1 Q. Re: GRK-NLH-21, rev. 1

2 Citation 1 (WMA Application, Appendix A, p. 4-11):

Figure 4: Muskrat Falls (Monitoring Station 03OE001) Hydrograph

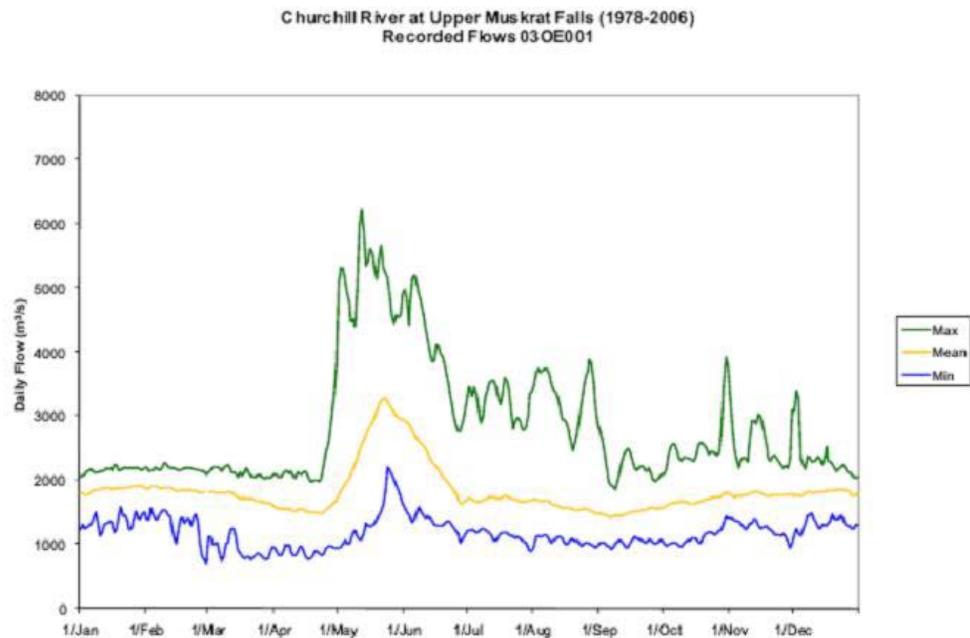
12 Figure 4 in Citation 2 shows that, in some years, flows on the Churchill River at
13 Upper Muskrat Falls exceed 2,660 m³/s throughout the summer.

1 **Please indicate the amount of spillage from Muskrat Falls in a year which flows on**
2 **the Churchill River at Upper Muskrat Falls equal those shown in the upper line of**
3 **Figure 4.**

6 A. The quantity of spillage from Muskrat Falls during a wet year with high inflows does
7 not affect production at Muskrat Falls or the reliability of the plant. Hydro has not
8 carried out the requested analysis and does not believe it is relevant to the present
9 proceeding. Hydro also notes that this is one potential hydrological sequence,
10 which may or may not occur and is thus a single hypothetical scenario. In this
11 regard, please see Hydro's response to GRK-NLH-104.

20 Flows in excess of the 2,660 m³/s rated discharge referenced above will be spilled.
